22/03224/EFUL

Former Gasworks, Windsor Bridge Road, Twerton, Bath, Bath And North East Somerset,

Objection - 21/10/2022

Fig. 1: Western Riverside Spatial Masterplan - Proposed Building Heights

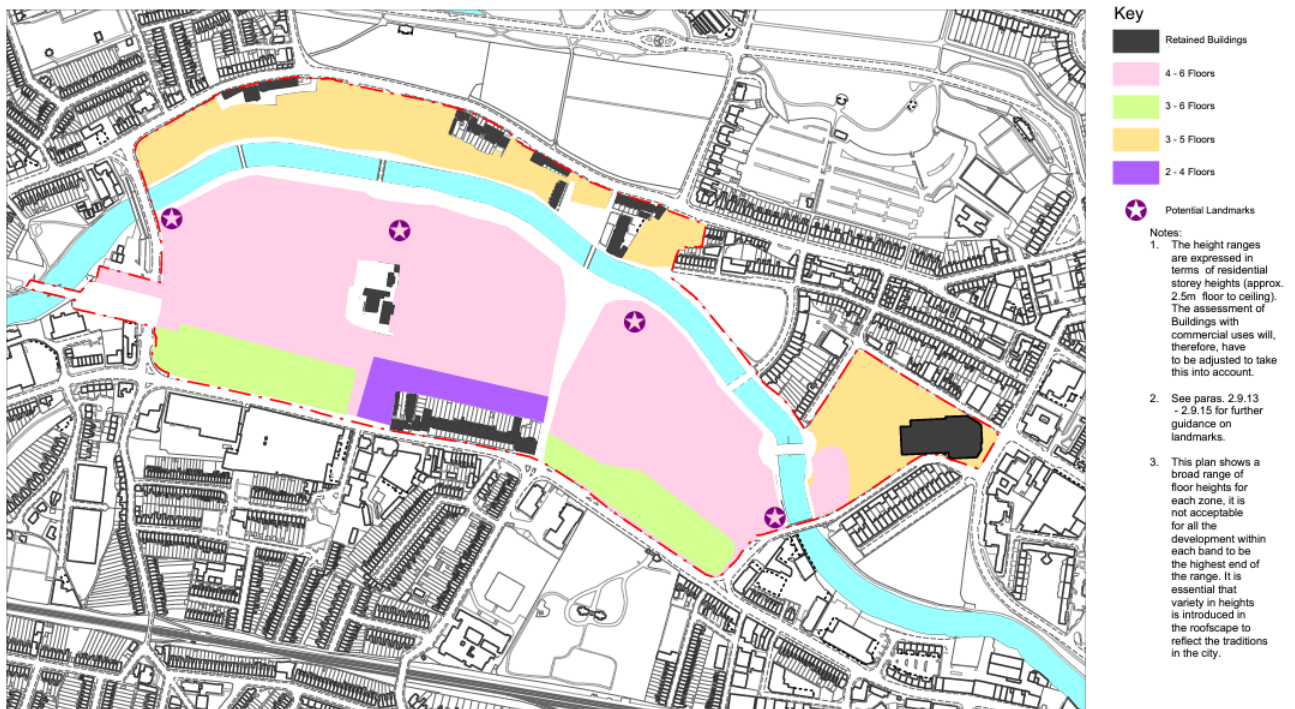
The Bath Western Riverside Spatial Masterplan SPD originally indicated that the area is allocated for development of an approximate height of 4-6 floors (see Fig. 1), where this *“would not have unacceptable townscape or visual impact on the City and, subject to analysis of specific proposals and to detailed design, are likely to be acceptable.”* The Masterplan highlights that Bath is typically characterised by a lack of tall buildings, apart from the punctuation by key buildings and Spires such as the Abbey - *“generally other tall buildings that have been developed have harmed the integrity and balance of city views.”*

Policy SB8 of the Core Strategy and Placemaking Plan indicates a development target of *“around 1,500 dwellings”* of a *“high-density urban form”*. However, development is also expected to *“create an appropriate townscape that relates to the scale of the Upper Bristol Road / this key route into the city, rather than seeking to create a ‘gateway’ or landmark buildings.”* Development would adversely reinforce the increasing scale and massing of contemporary development in this area and continue to push the boundaries of maximum height, with continued detriment to the established historic form, grain, and layout of the area.

The proposed development would therefore be excessive in scale, contrary to local guidance and height parameters. Whilst we recognise the need for high density development as set out in local policy, this does NOT consequently justify high rise development where this would be of detriment to the setting of the conservation area and the OUV of the World Heritage Site.
